Plan Commission

Agenda

Monday, July 22, 2019

SUBJECT: Staff recommendation and possible action regarding a Site Plan for a new dental office and off-street parking areas at 221-233 S. Erie Street (Parcels ED-1112, ED-1113, ED-1114). Submitted by Katie Nemitz, Design Unlimited, authorized representative for HNM LLC, property owner.

**SITE STATISTICS**

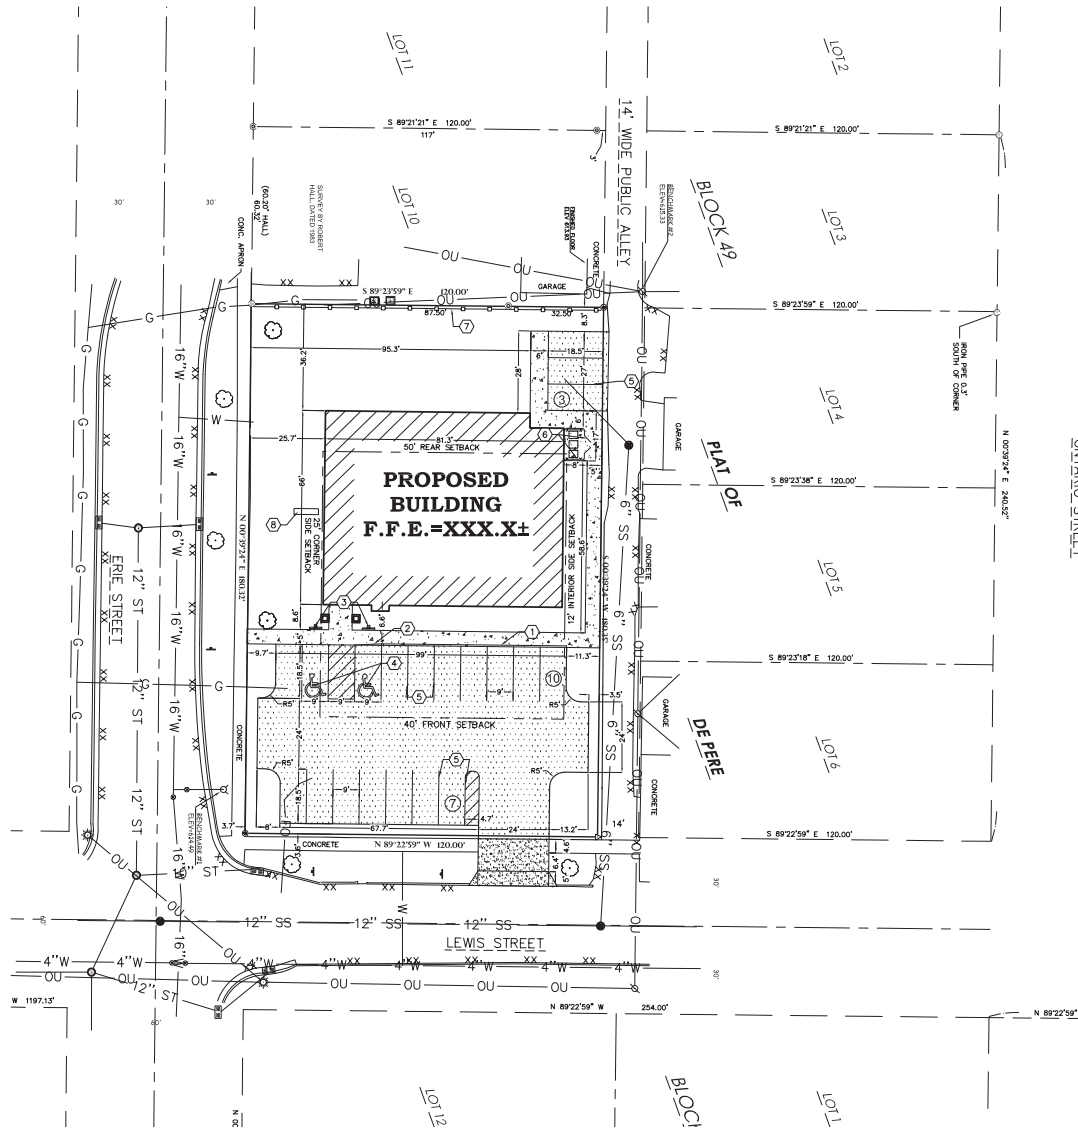
11. Clarify if the contours shown on sheet C2.0 are proposed or existing. Both are required.
12. Need to show utilities entering the building (gas, electric, water, sewer, storm). Is the plan to reuse any of these services?

13. Need an excavation and grading plan. Perimeter curb along the parking lot will be required to prevent water from sheeting across the sidewalk. An inlet should be considered as the City will not allow the water to sheet flow out of this parking lot across sidewalk.

4. The site plan identifies that HVAC systems will be screened with landscaping, but the size of the HVAC system is unknown. Provide updated site plans that show the properly screened HVAC system.

5. Provide a scaled elevation, with materials and color identified, for the fence along the north boundary of the site.
6. Provide dimension on site plan that identifies setback for monument sign, which must be at least 15 feet. Revise the sign plan lighting to be either unlit, externally lit, or backlit/halo as internally lit signs are not allowed.

C1-10

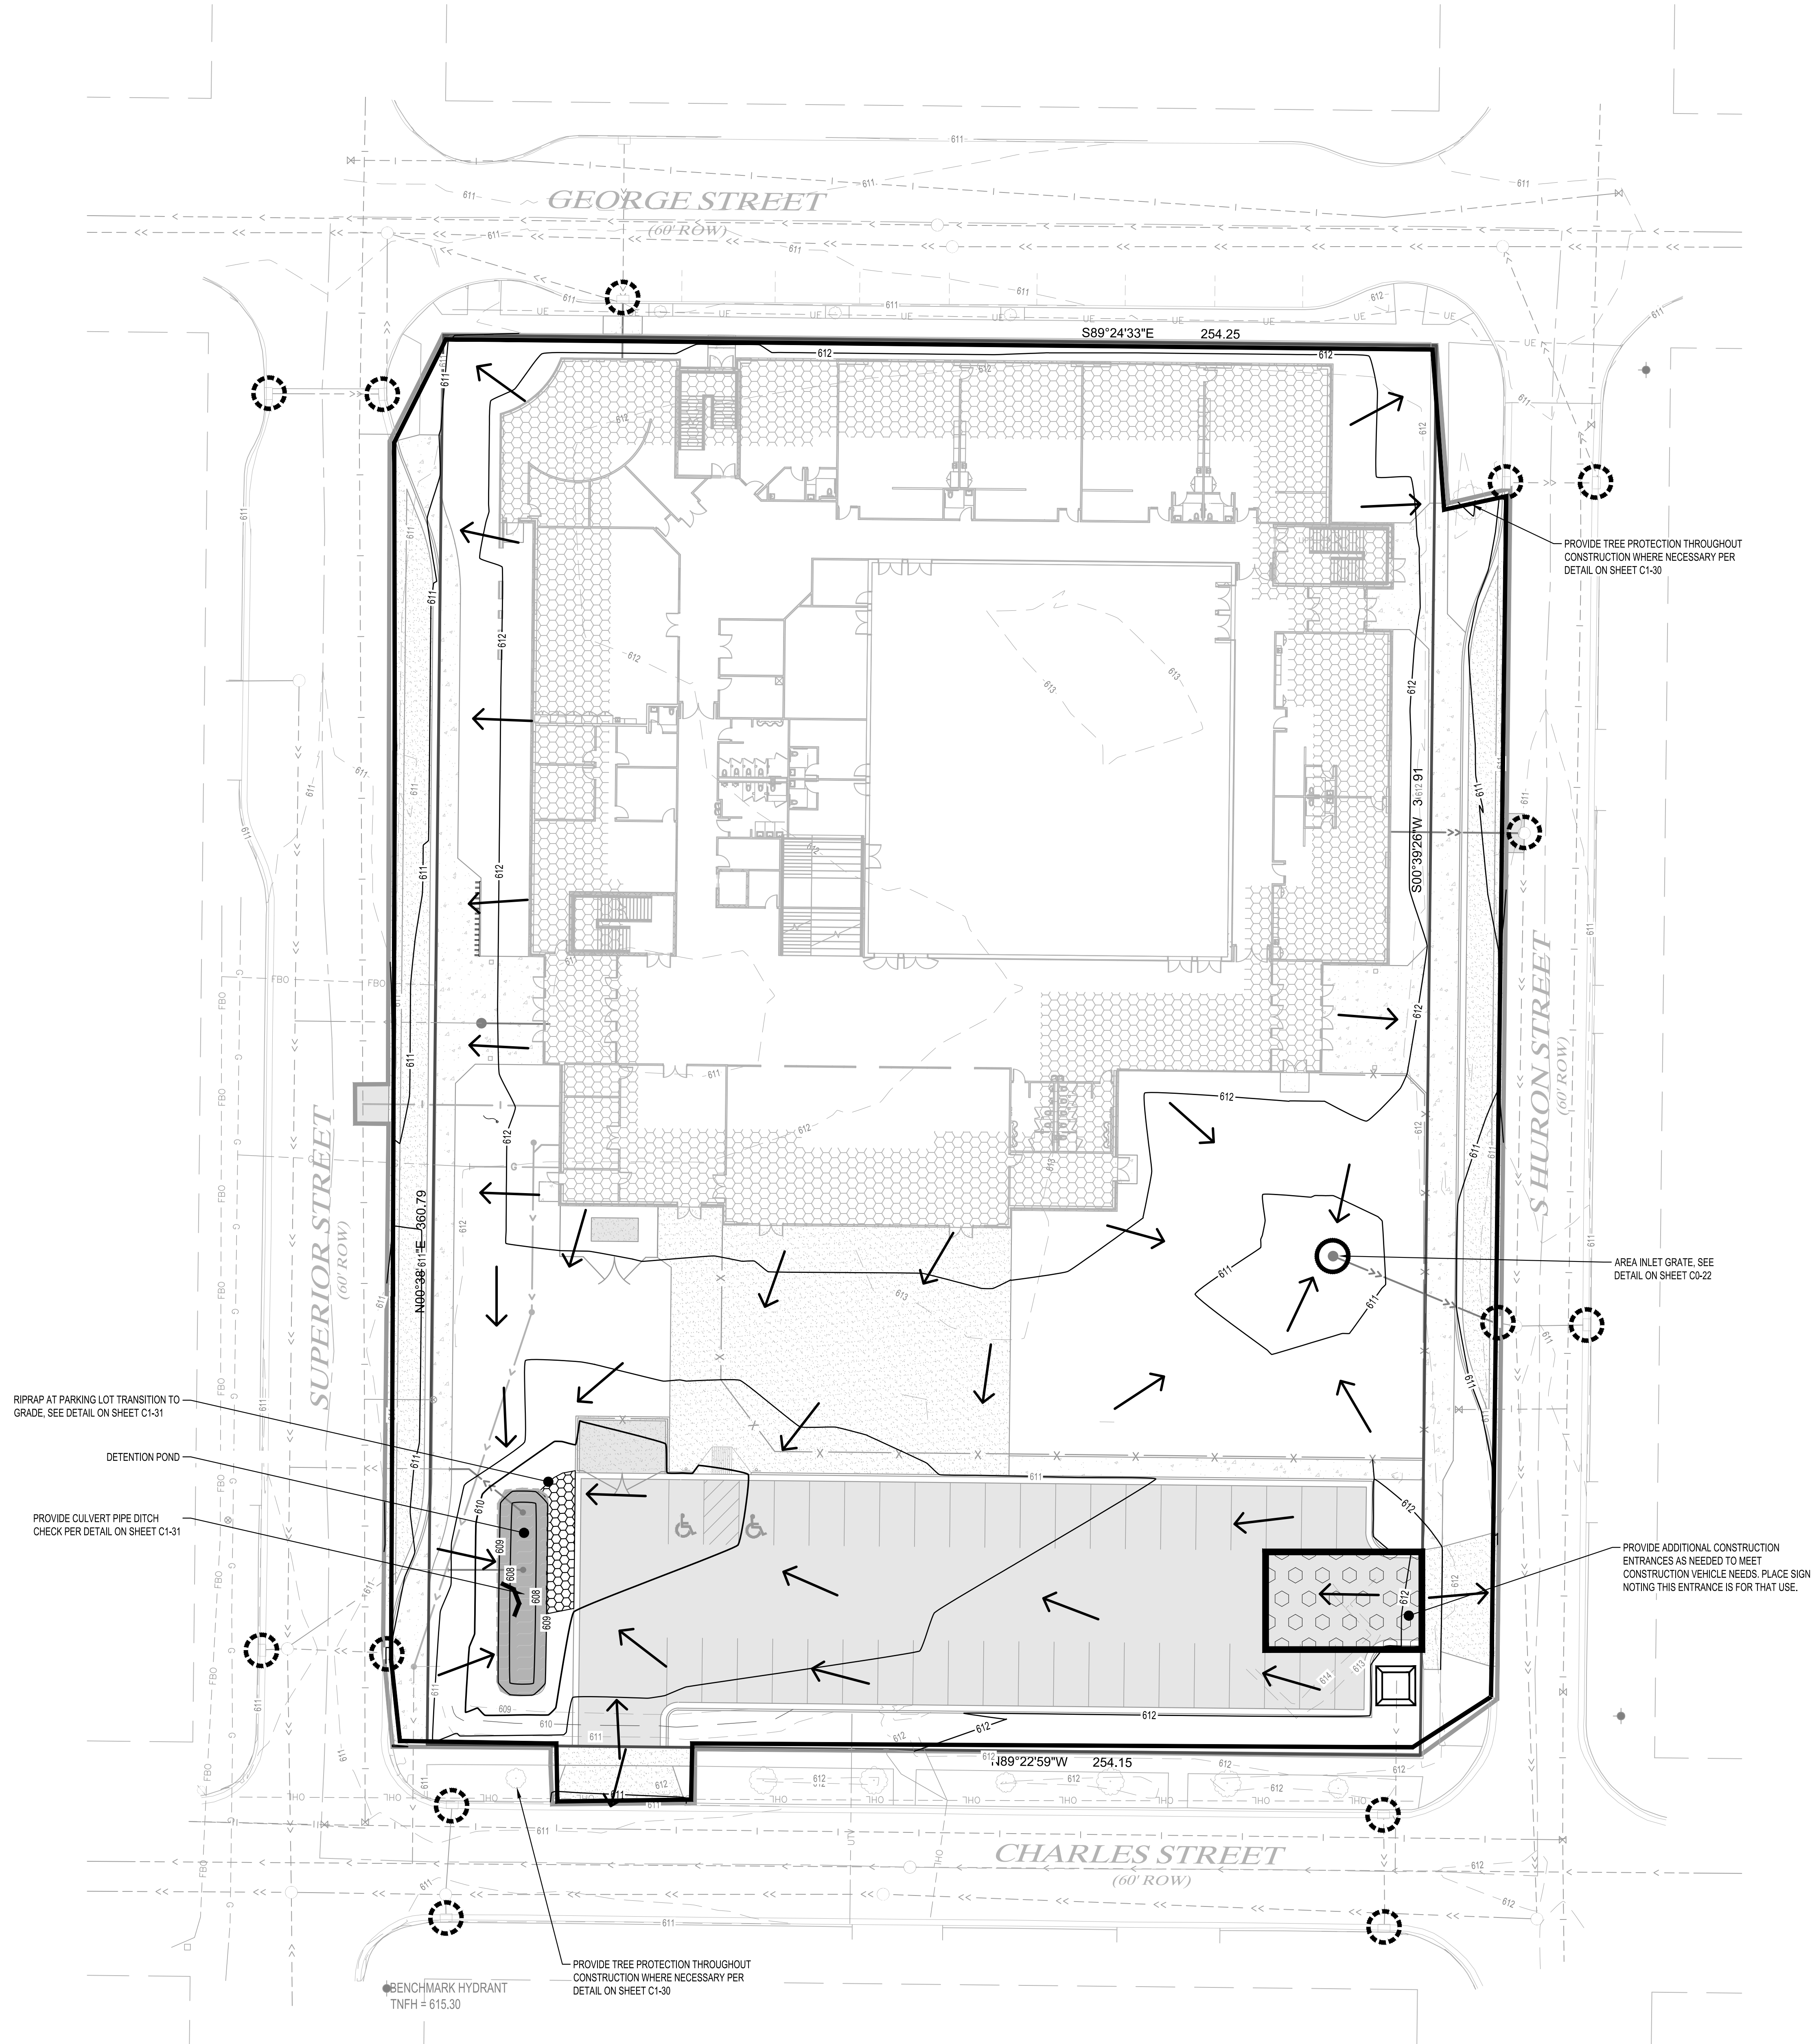
2. Stockpile locations will need to be called out and erosion control provided at these locations. Inlet protection Type D is required at all inlets. Call out inlet protection type D on plans. (Sheet C1-10).
